Subject: **Palo Verde Nuclear Generating Station (PVNGS)
Units 1, 2, and 3
Docket Nos. STN 50-528, 50-529, and 50-530
APS Response to Request for Additional Information Regarding
Overall Integrated Plan for Implementation of Order EA-12-051, *Reliable Spent Fuel Pool Instrumentation***

**Response to NRC RAIs Regarding Overall Integrated
Plan for Implementation of Order EA-12-051, *Reliable
Spent Fuel Pool Instrumentation***

Order EA-12-051, Reliable Spent Fuel Pool Instrumentation RAI #1

Figure 1

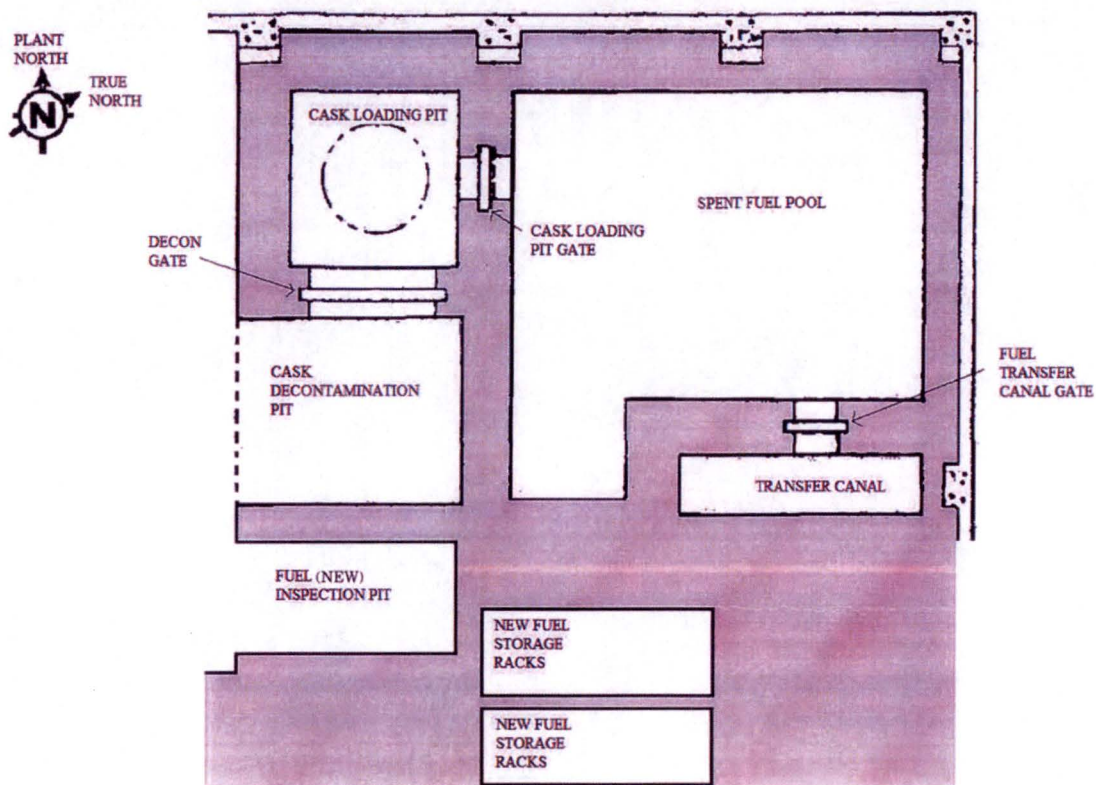
- a) A description of how the other structures in the vicinity of the SFPs (cask loading pit, transfer canals and gates) shown in Figure 2, "Spent Fuel Pool Geometry and Dimensions" are connected to the SFPs.**
- b) If additional structures, other than the SFPs in each unit, are used for fuel storage, describe in detail their usage, operation, and provide justifications for not installing separate level instrumentation in other structures used for fuel storage.**

- a) The Spent Fuel Pool (SFP) is connected to two refueling structures; the Transfer Canal and the Cask Loading Pit, reference Figure 1. A Seismic Category I gate, with dual seals separates the inventory between the SFP and the Cask Loading Pit. A Seismic Category I gate and seal separates the inventory between the SFP and the Transfer Canal. This seal is currently being modified to a dual seal design independent of Order EA-12-051. In addition, a Seismic Category I gate, with dual seals, separates the inventory between the Cask Loading Pit and the Cask Decontamination Pit, which connects to the Fuel Building at grade elevation. This gate is only removed during dry cask campaigns when the gate between the SFP and Cask Loading Pit is installed. The lowest elevation of the gate between the Cask Loading Pit and the Cask Decontamination Pit is 124 feet, 0 inches which is above the top of the SFP storage rack (114 feet, 2 inches). The dual gate seals are pressurized by a redundant air and nitrogen gas supply and have an additional Seismic Category I back-up nitrogen source. The SFP is configured to comply with the requirements of Regulatory Guide 1.13, *Spent Fuel Storage Facility Design Basis*, Revision 0.

Routing of Sensor Cables from Sensor Location to Display Locations
Figure 2

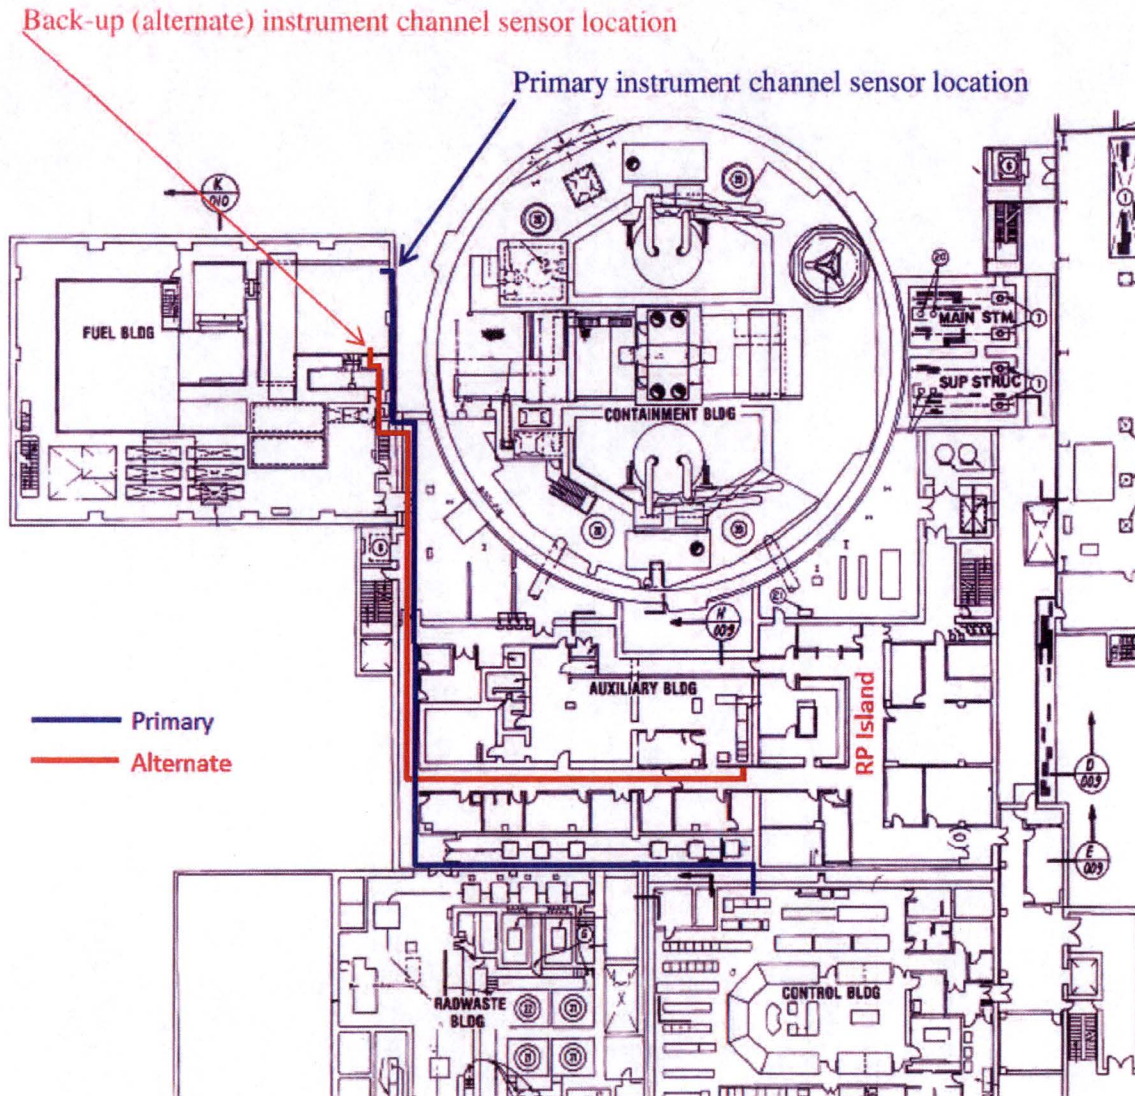
- a) The final locations/placement of the primary and back-up SFP level sensor.**
- b) Additional information describing how the proposed arrangement of the sensor probe assembly and routing of the cabling between the sensor probe assembly and the electronics in the Auxiliary Building meets the Order requirement to arrange the SFP level instrument channels in a manner that provides reasonable protection of the level indication function against missiles that may result from damage to the structure over the SFP.**

- a) The primary instrument channel sensor is mounted in accordance with JN350-A00038 (Reference 17 of this enclosure) in the northeast corner of the SFP on the east wall. The back-up (alternate) instrument channel sensor is located in the southeast corner of the Spent Fuel Pool (SFP) on the south wall, as shown in Figure 2.

The sensors are located close to the side walls of the SFP and below the floor elevation to utilize the pool walls as inherent protection. From the primary sensor, the primary signal cable, contained in rigid metal conduit, is run east along the floor to the east wall of the Fuel Building. The primary signal cable is then routed along the east wall until it penetrates the wall into the Auxiliary Building. From the alternate sensor, the alternate signal cable, contained in rigid metal conduit, is run east along the floor to the east wall of the Fuel Building. The alternate signal cable is then routed along the east wall until it penetrates the

Once the cables enter the Auxiliary Building they are routed to separate locations prior to connecting to the electronics. The SFP walls and corners provide inherent missile protection for the level sensor cable. See Figure 2 for a depiction of the conduit routing.

Figure 3

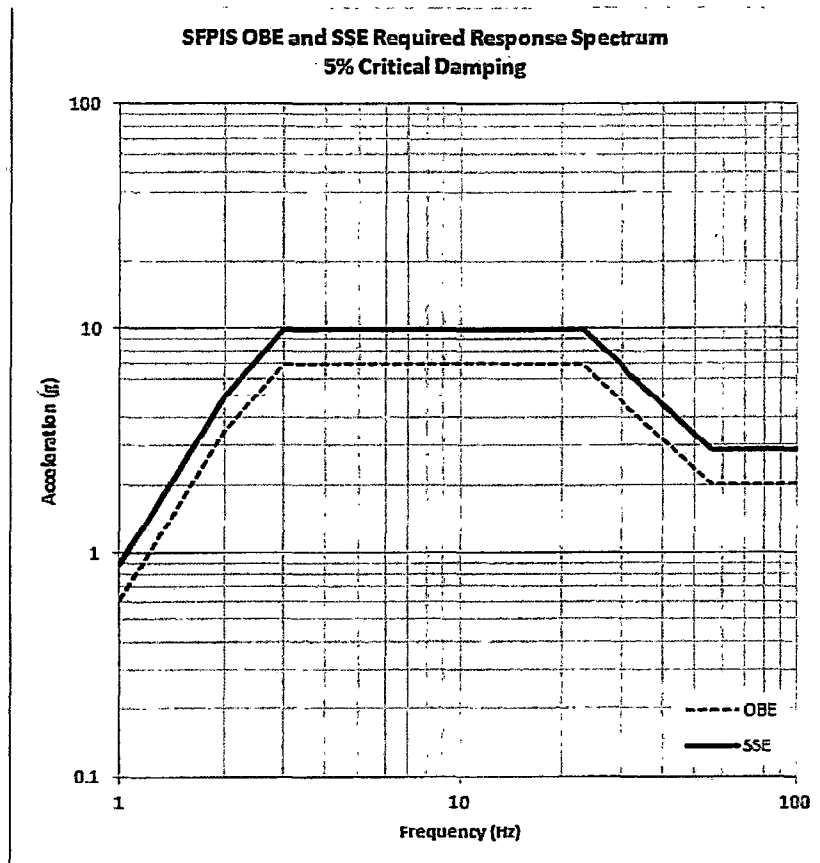
Please provide the analyses verifying that the seismic testing of the sensor probe assembly and the electronics units, and the licensee's analysis of the combined maximum seismic and hydrodynamic forces on the sensor probe assembly exposed to the potential sloshing effects, show that the SFP instrument design configuration will be maintained during and following the maximum seismic ground motion considered in the design of the SFP structure.

Spent Fuel Pool Instrumentation System (SFPIS) Equipment (sensor and electronics): The seismic testing for the Sensor and Electronics is documented in JN350-A00076 (Reference 4 of this enclosure). The seismic testing was satisfied for SSE in accordance with IEEE 344-2004, *IEEE Recommended Practice for Seismic Qualification of Class 1E Equipment for Nuclear Power Generating Stations*, Required Response Spectra (RRS) to IEEE 323-2003 with 10% margin included. SSE is shown in Figure 3. The Operating Basis Earthquake (OBE) RRS at 5% critical damping was at least 70% of the respective SSE seismic level of Figure 3.

The sensor and electronics met each of the required performance and acceptance criteria, maintained structural integrity during the acceptable SSE test runs, and acceptable OBE test runs to the RRS. Acceptable functionality of the electronics and
